Application No. 10/606,571  
Amendment Dated April 20, 2006  
Reply to Office Action Dated October 20, 2005

**Amendments to the Drawings:**

FIG. 3A

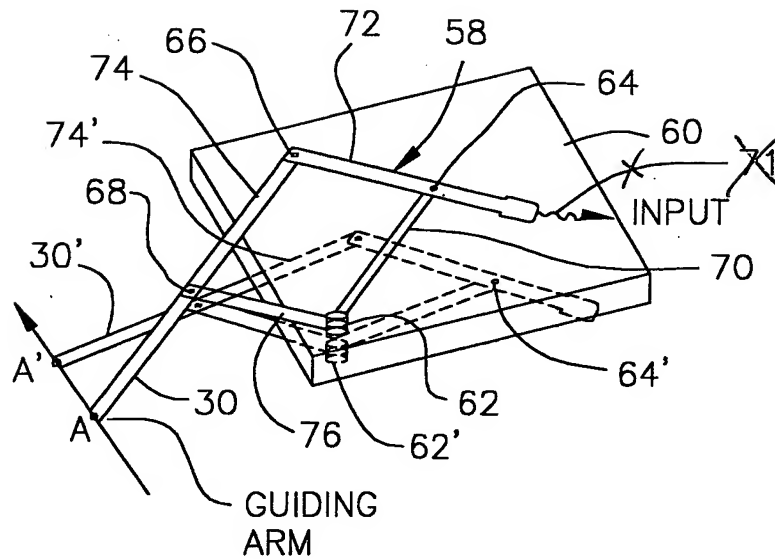
In the first portion of the Office Action, the Examiner has objected to the drawings because the angle E was not shown in the Figures and in Fig. 3a, element number 70 appears to be used to designate a signal line from the encode.

Applicant begins by noting that element 70 on Fig. 3a is one of the four arms on pantograph 58 as the element line for 70 would indicate. The extraneous element number 71 on Fig. 3a has been deleted.

The attached sheet of drawings includes changes to Figs. 3a and 3b. This sheet, which includes Figs. 3a and 3b replaces the original sheet including Figs. 3a and 3b. In Fig. 3a the element number 71 was removed and in Fig. 3b, the reference designation "B" was changed to "E" for the angle between element 70 and the x-axis.

FIG. 3B

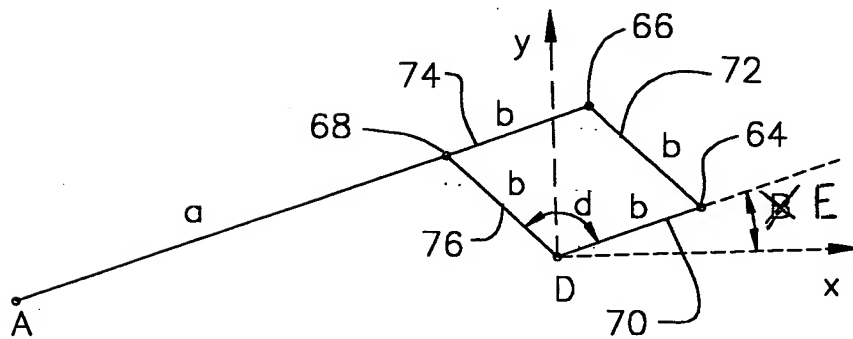
Regarding the angle E, Fig. 3B has been corrected to properly show this element as defined in the specification, namely the angle between arm 70 and the x-axis, which was originally improperly labeled B.
